8.1.4 Engineering Change: Addition of Anti-Spurious Filter

ENGINEERING NOTICE #:280-9A-001 DATE:99.1.2 RUSH

Title: Addition of Input Harmonic Filter

TITLE: OFR-P300F FRONT END

DESIGN MODIFICATION
ECN 280-9A-001

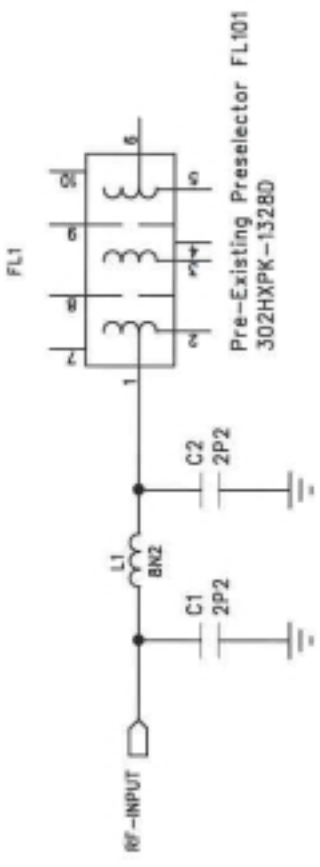
Reason for Change: Unit failed FCC Part 15 Antenna Conducted Spurious Test
Bring design into compliance.

Part Number	Complete Description Of Change	<input checked="" type="checkbox"/> Drawing Chg. <input checked="" type="checkbox"/> BOM Chg. <input type="checkbox"/> Initial Release
<u>00M1030.DWG</u>	<u>To add filter to schematic</u>	
<u>BOM FE9M</u>	<u>Add 8n2 0603 Inductor, 2pcs 2p7 0603 ceramic cap</u>	
<u>Process Instruction</u>	<u>Add components on underside of PCB near input to preselector.</u>	
	<u>Cut trace and expose groundplane for connection</u>	
	<u>Advise to keep center conductor exposure to a minimum.</u>

NOTES: COMPONENTS TO BE HAND SOLDERED
ON UNDERSIDE OF PCB
RF INPUT TRACE TO BE CUT AND GROUNDS EXPOSED AS NEEDED
THIS AMENDS 00MIC030.DWG

Implementation Notes: Hand modify existing stock See report and drawings attached.

Update layout when reordered.

Skytel OFR Rx Antenna Conducted Emisision
(Unmod: f:nd)

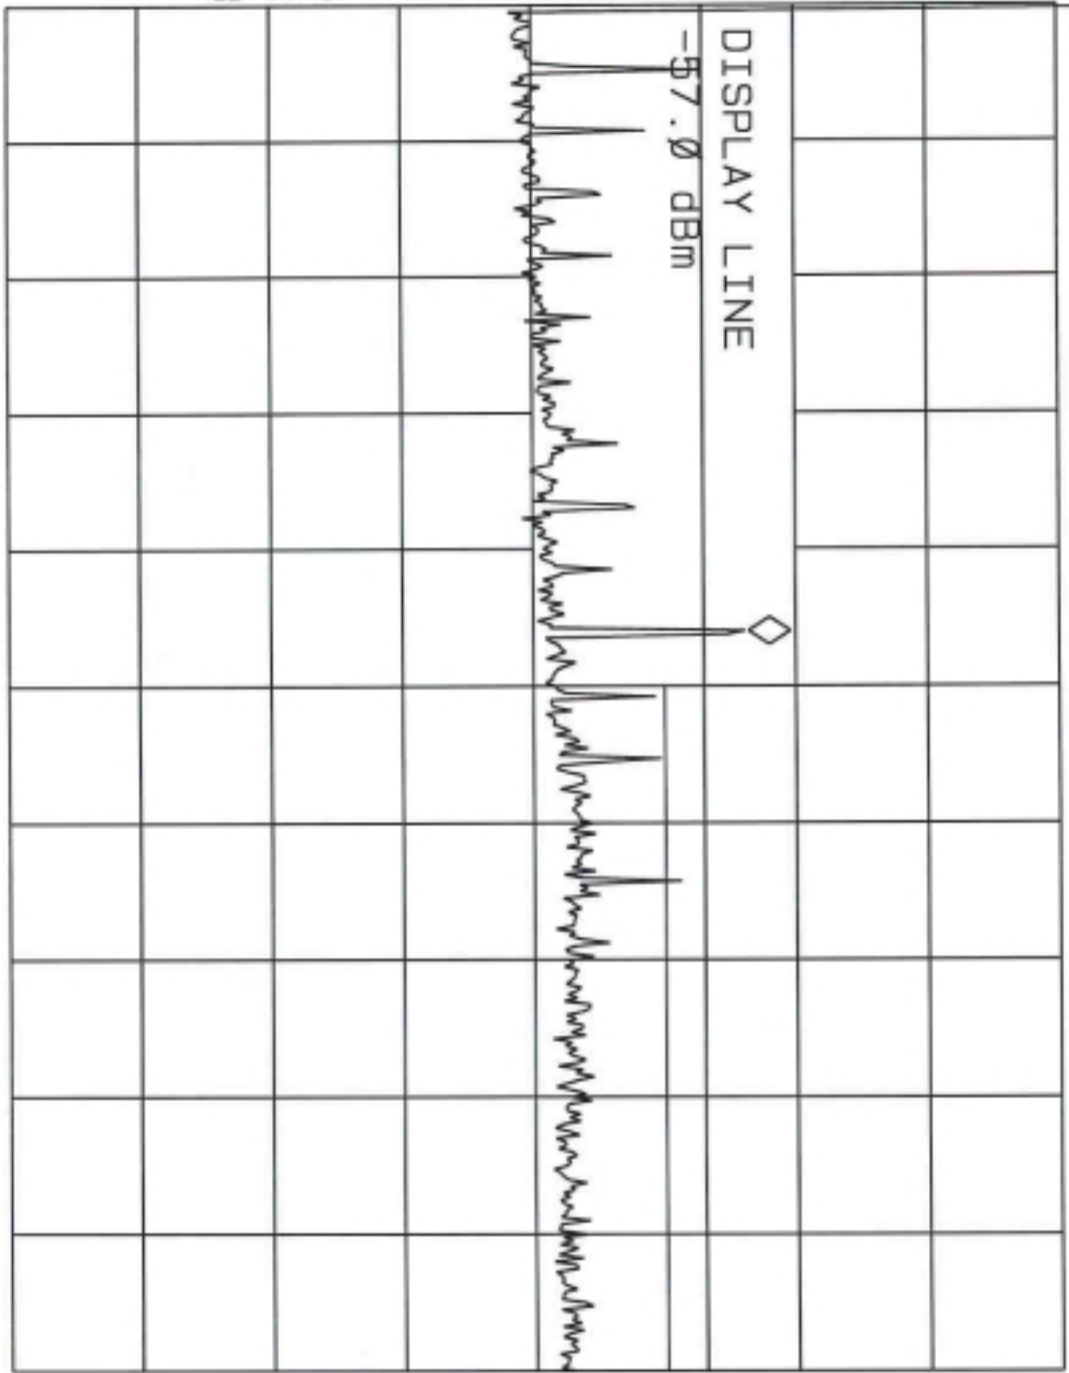
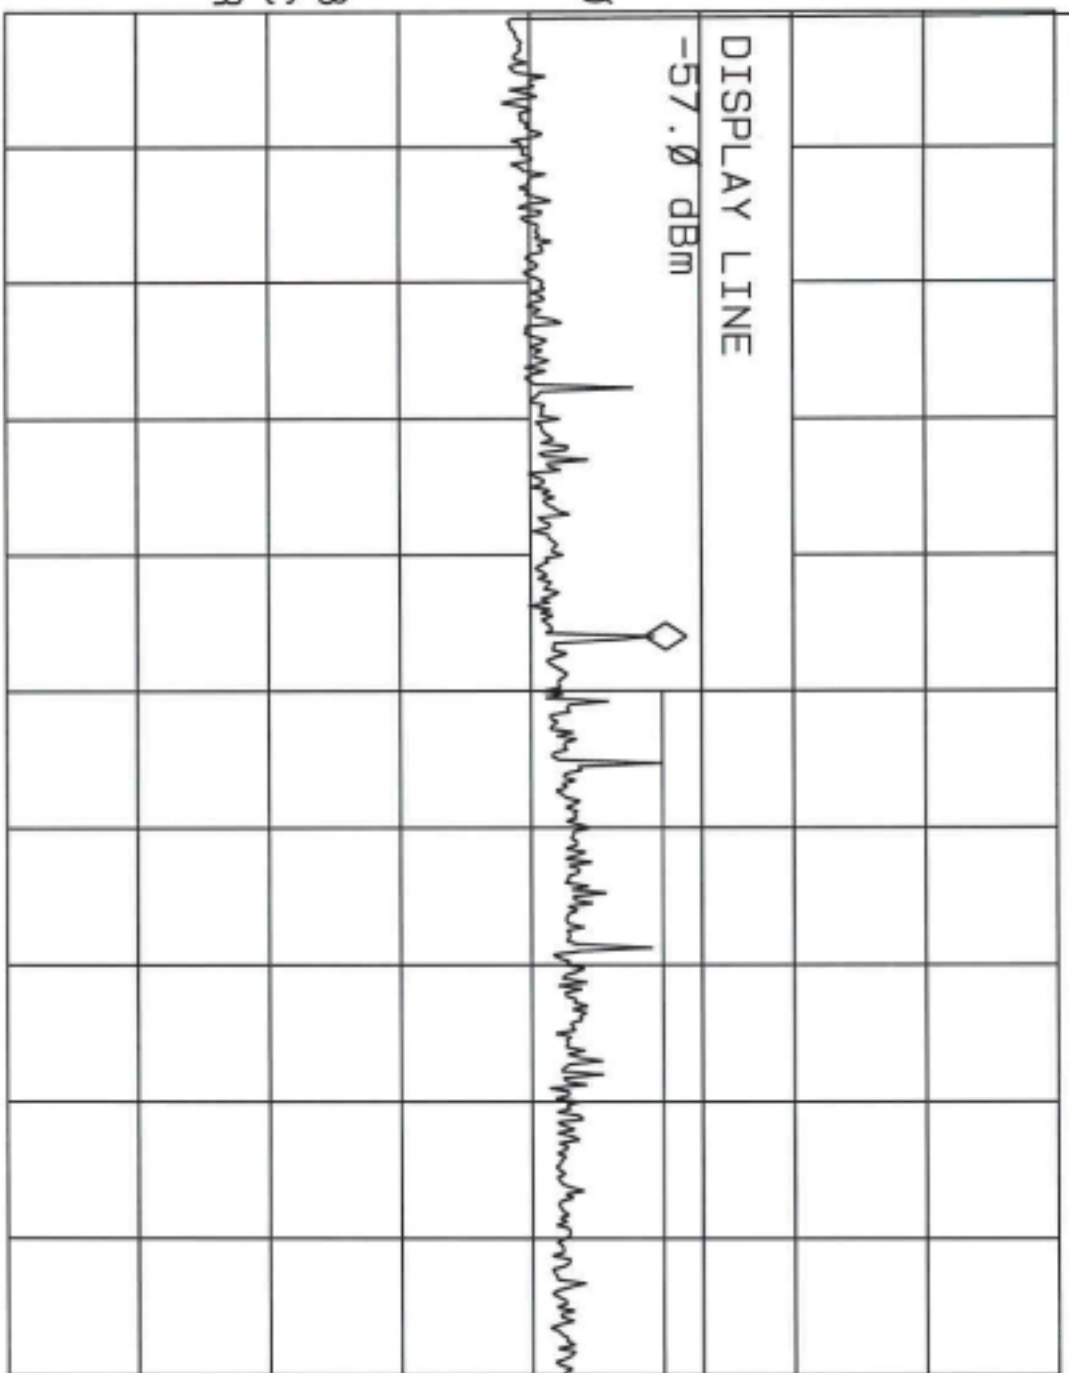
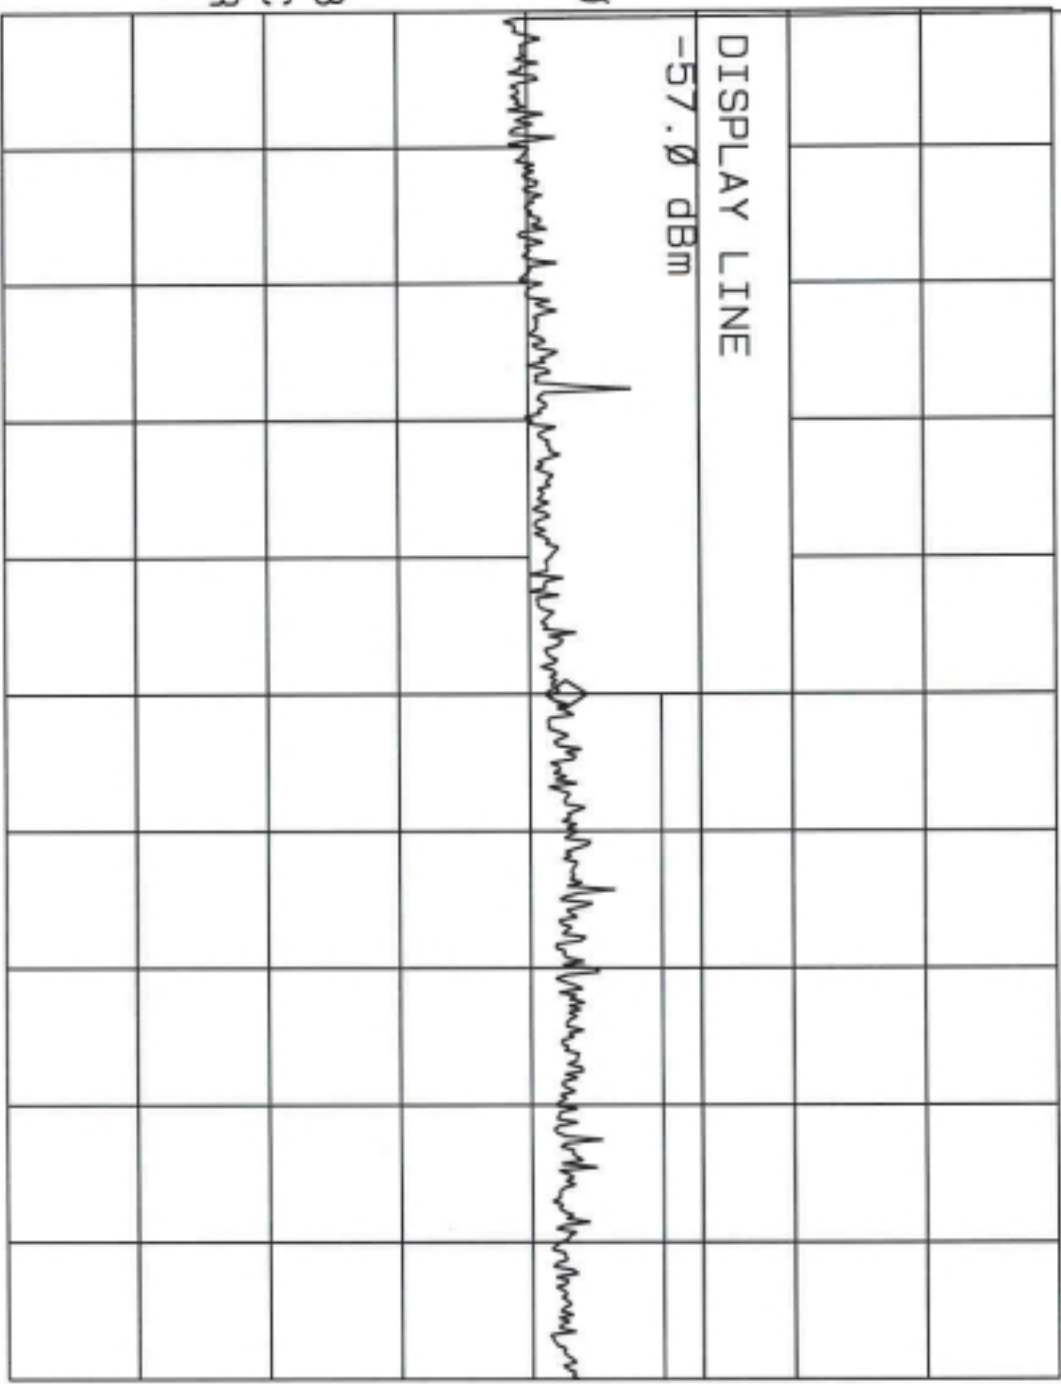
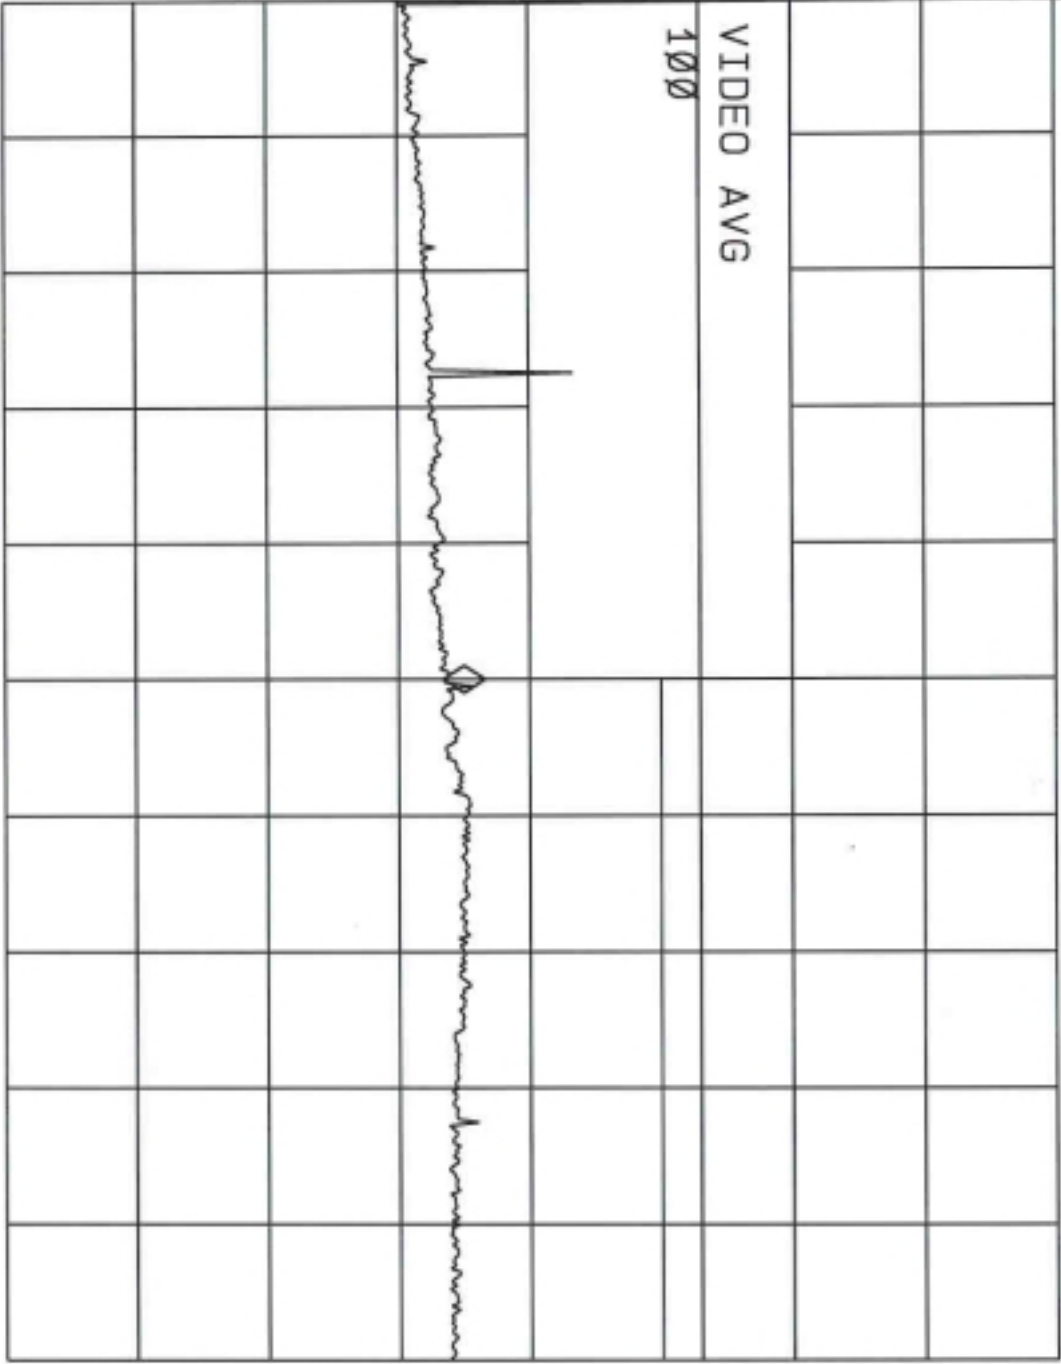
US Tech informed me that the Skytel OFR failed FCC Part 15.111 antenna conducted emissions tests. Any product must radiate less than 2 nW (-57 dBm) at any frequency up to 5 GHz. Some spurs between 2 GHz and 3 GHz violate this requirement or are uncomfortably close.

Two changes must be made. The first is a workmanship issue. Any excess exposed center conductor in the input RF connector pigtail acts as a pickup antenna at microwave frequencies. L.O. harmonics are easily picked up. You should use flexible semirigid cable for this application and trim the exposed center conductor at the PCB end of the cable to the absolute minimum length. You cannot allow production to get sloppy with this. The unit I got had over 1/2 inch of exposed wire.

Cable trimming made about 8 dB of difference at 2.3 GHz.

This still left too close a margin. I added a simple PI lowpass filter on the underside of the PCB. This involves a trace cut and removal of some solder mask. 0603 caps and inductors were used. You must implement an Engineering Change Order that adds this filter to all Skytel OFRs. We did not design the L.O. so our bills of materials will not reflect this change, as they call up the module as a single part. SMA can write up the ECO if you wish.

Final performance resulted in spurs so low they were hard to measure. We obtained at least a 20 dB improvement in my estimation. Also, the filter improved the input return loss and front end sensitivity. I postulate that the PI filter acts as a matching network between the connector and helical preselector.
